A Review of the South Texas Project Probabilistic Safety Analysis for Accident Frequency Estimates and Containment Binning

Prepared by
T. A. Wheeler, J. L. Darby, J. A. Lambright
T. T. Sype, B. Walsh

Sandia National Laboratories
Operated by
Sandia Corporation

Prepared for
U.S. Nuclear Regulatory Commission

Figure 6.2.1.1-5

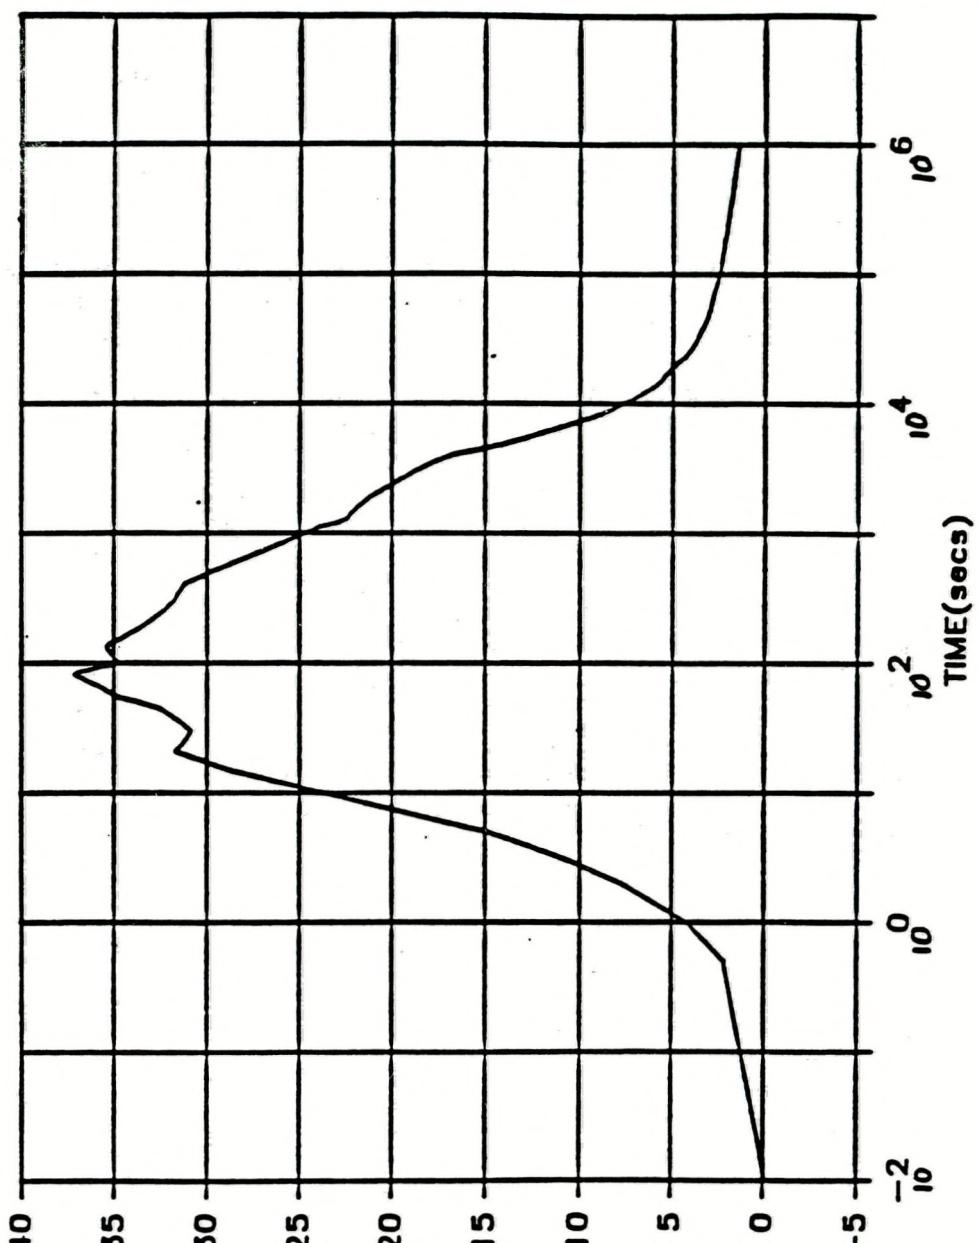
The large LOCA event tree does not address the effect of failure to isolate containment on the ability to reflood the core. If the containment pressure is lower than the minimum back pressure used in the LOCA licensing analyses, reflood of the core occurs at a lower rate. [Reference 6, Sections 6.2.1.1.1.6 and 6.3.3, and Figure 6.2.1.5. Reference 7, Section 6.2.1.5.] In item IE4 of Appendix 3, HLP justified the assumption that the effect of lower containment back pressure has negligible effect on the ability of the ECCS to prevent gross core damage. Even though the peak clad temperature may reach approximately 2510°F, well above the LOCA licensing limit of 2200°F, it is well below the zirconium phase transition temperature of 2900°F.

Failure to isolate containment following a large LOCA is considered to impact the core reflood rate, but not result in significant fuel clad damage. This conclusion is based on the discussion presented below.

The UFSAR Chapter 15.6 describes the analyses performed for the design basis large LOCA. The LOCA analyses account for containment pressure in assisting the core reflooding rate during the reflood phase (i.e., the higher the containment pressure, the faster the reflood). The rate of reflooding affects the calculated Peak Clad Temperature (PCT). Westinghouse has identified that a conservative estimate for the effects of a change in containment pressure is 50°F of PCT for 0.5 psi of containment pressure. The limiting break in terms of PCT is the double ended cold leg guillotine break with a discharge coefficient of 0.6 and maximum SI flow (from UFSAR Table 15.6-7). UFSAR Figure 15.6-26 presents a plot of PCT and UFSAR. Figure 15.6-31 presents a plot of the containment pressure for the limiting large LOCA. The large LOCA analysis in Chapter 15.6 assumes that the 18 in. supplemental purge lines are open at the start of the event and are isolated at 23 seconds into the event. From Figure 15.6-26, PCT occurs at approximately 130 seconds with a containment pressure of 8 psig. Assuming that the supplemental purge lines remain open throughout the LOCA transient, the rate of containment depressurization will be greater than that presented in UFSAR Figure 15.6-31.

A conservative estimate for the pressure loss through the two supplemental purge lines results in an additional decrease in containment pressure of 3.8 psi. This is equivalent to an increase in PCT of 380°F using the vendor rule of thumb presented above. This increases the PCT to less than 2510°F. This temperature is above the PCT limit of 2200°F for the UFSAR LOCA analyses but below the zirconium phase transition temperature of 2900°F. Staying below the zirconium phase transition temperature ensures no clad melting and no significant increase in the clad oxidation rate. Therefore, in terms of the PSA success criteria, no core damage occurs if the supplemental purge lines remain unisolated for a Large LOCA.

ECCS Train A
Simplified Schematic

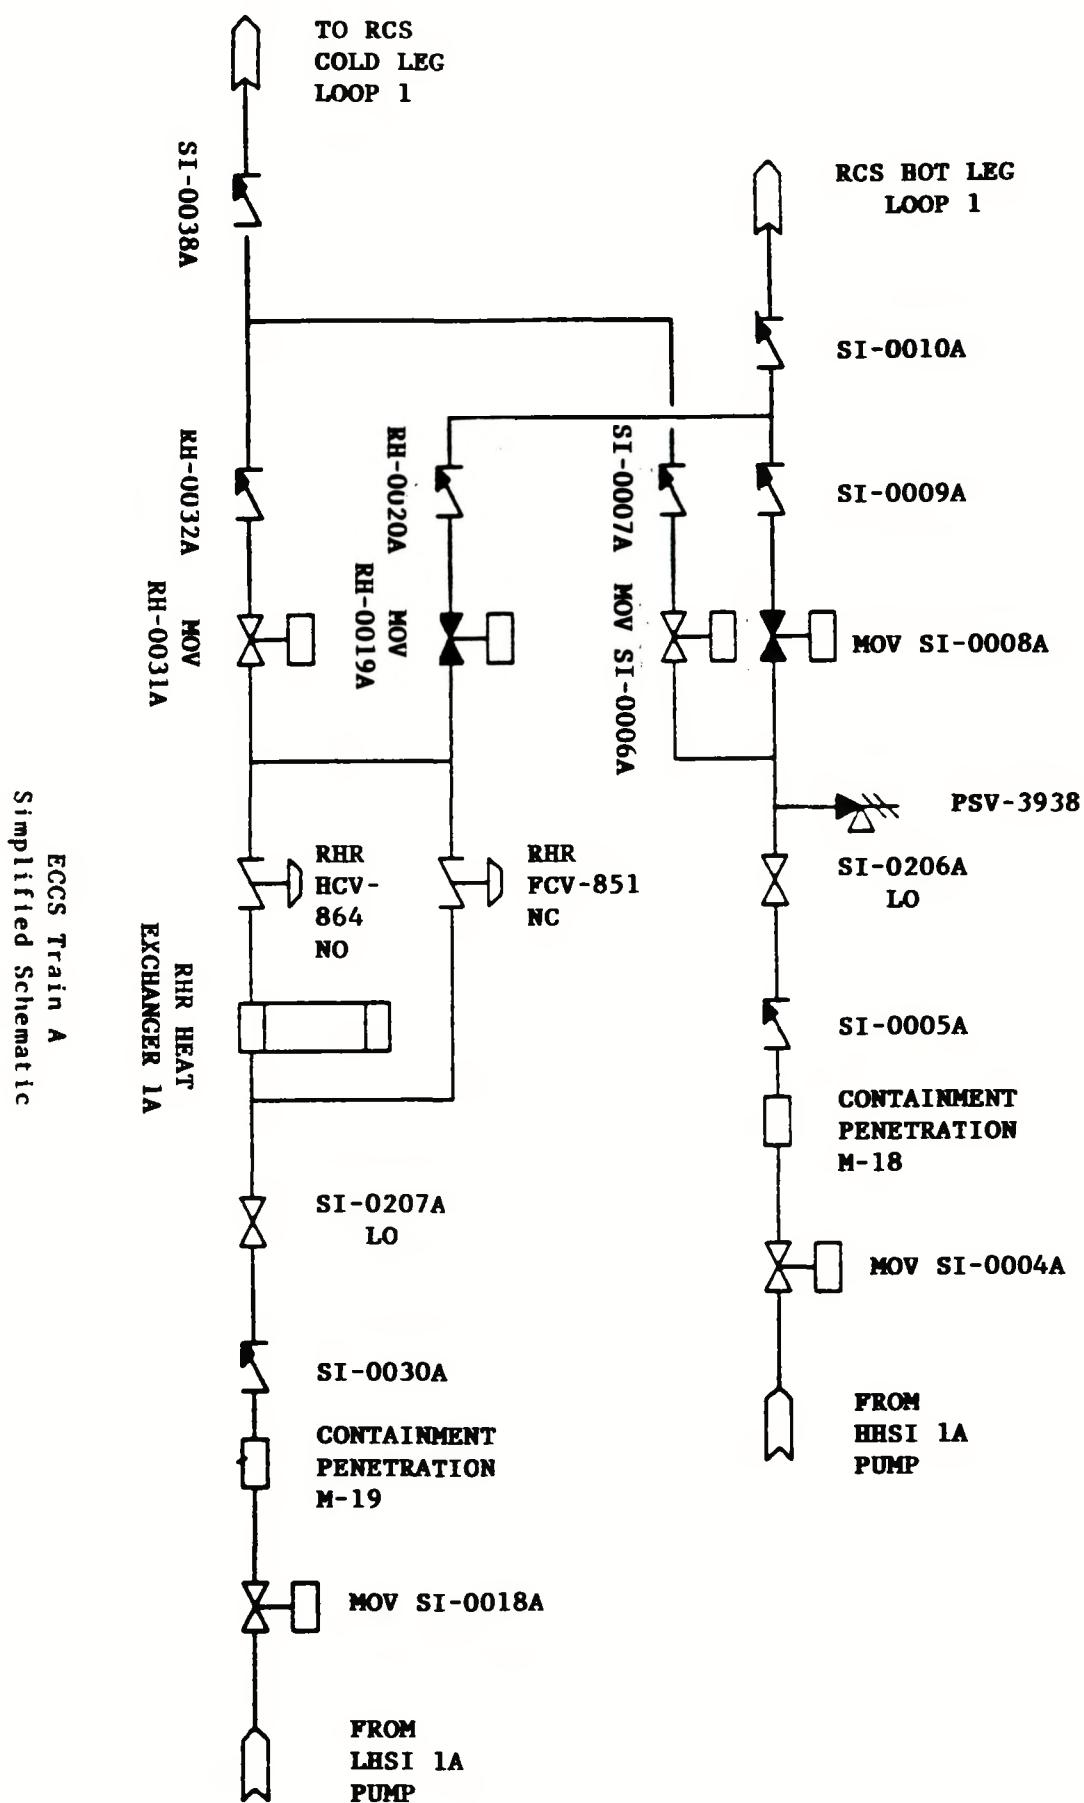
4. The new analysis does not consider the possibility that the operator successfully acts to close the necessary MOV to mitigate the leak, only to have the MOV fail to close on demand. Since no data is provided for failure of the valve to close, it appears that the new analysis assumes that failure of the valve to close on demand is much less likely than failure of the operator to initiate the closure action. In most circumstances, this assumption would be valid, but it requires further justification in this instance. The valve in question (MOV RH-0031) may not be able to close against reverse flow unless its torque switches are set to allow for this flow. This is an important point since without successful mitigation, the V sequence frequency is comparable to other dominant core damage sequences for the STP PSA and should not be screened.

After the failure of the first two check valves in the high pressure section of the injection lines, there will be ample signal to the control room that the RCS has leaked into the low pressure piping. If the relief valve lifts, the control room operators will be alerted by the alarm received from the RCS PRT about the increasing water level. Even if the relief valve does not lift, there will be alarms from the temperature and pressure instrumentation in the low pressure piping. To close RH0031, an
